Product / Process Change Notification

N° 2020-176-A

Capacity expansion with introduction of an additional assembly and final test location at Huayi Microelectronics Co., Ltd (HYME), China for dedicated TO220 3L MOSFET products in Gen 5.X/7.X/10.X

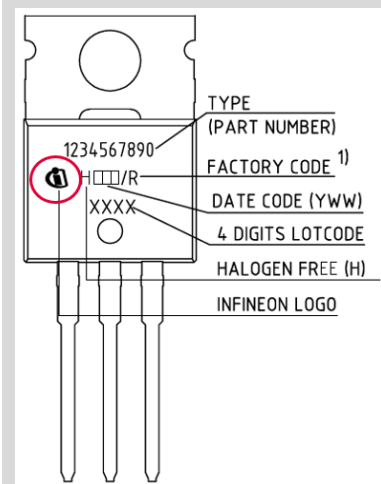
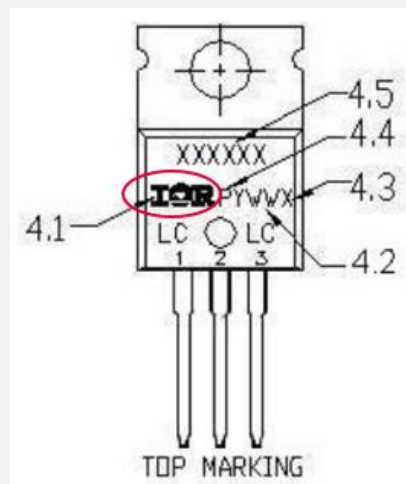
Marking on device:

| <ul style="list-style-type: none"> ■ Legacy International Rectifier (IR) logo | <ul style="list-style-type: none"> ■ Legacy Infineon logo <p>Note: Existing there are slight variations in the marking layout across different production site.</p> |
